# ATAAB ADVISORY NOTE

ATAAB Advisory Note Number: AN 16R000

**Subject:** Amendment of the test for compliance for resistance to earth to reduce the influence of the feeding bridge on the results of the measurement.

Test configuration:

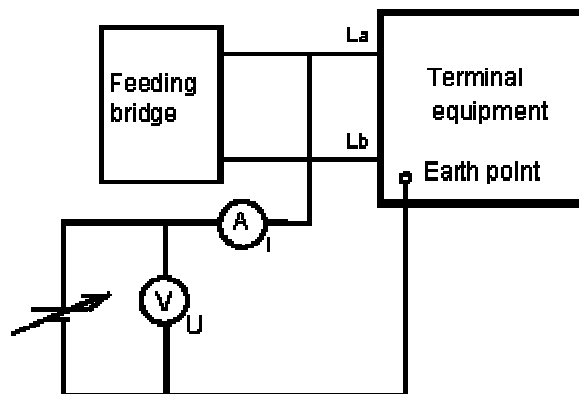
**The following revised test for resistance to earth measurement in the on-line state (TBR 21 clause: A.4.7.5):**

- 1) Connect the positive side of the feeding voltage to line terminal La of the TE;  
Connect the positive side of the test voltage to line terminal La of the TE;  
Measure the current  $I_1$ .
- 2) Connect the negative side of the feeding voltage to line terminal La of the TE;  
Connect the positive side of the test voltage to line terminal La of the TE;  
Measure the current  $I_2$ .
- 3) Connect the negative side of the feeding voltage to line terminal La of the TE;  
Connect the negative side of the test voltage to line terminal La of the TE;  
Measure the current  $I_3$ .
- 4) Connect the positive side of the feeding voltage to line terminal La of the TE;  
Connect the negative side of the test voltage to line terminal La of the TE;

Measure the current  $I_4$ .

Calculate the resistance to earth in branch La and Lb according to the formula:  $R_p=100/(I_1+I_2)/2$   
and  $R_n=100/(I_3+I_4)/2$

Verdict: If  $R_p$  and  $R_n$  is greater or equal to 1Mohm then Pass; else Fail. (from TBR 21)
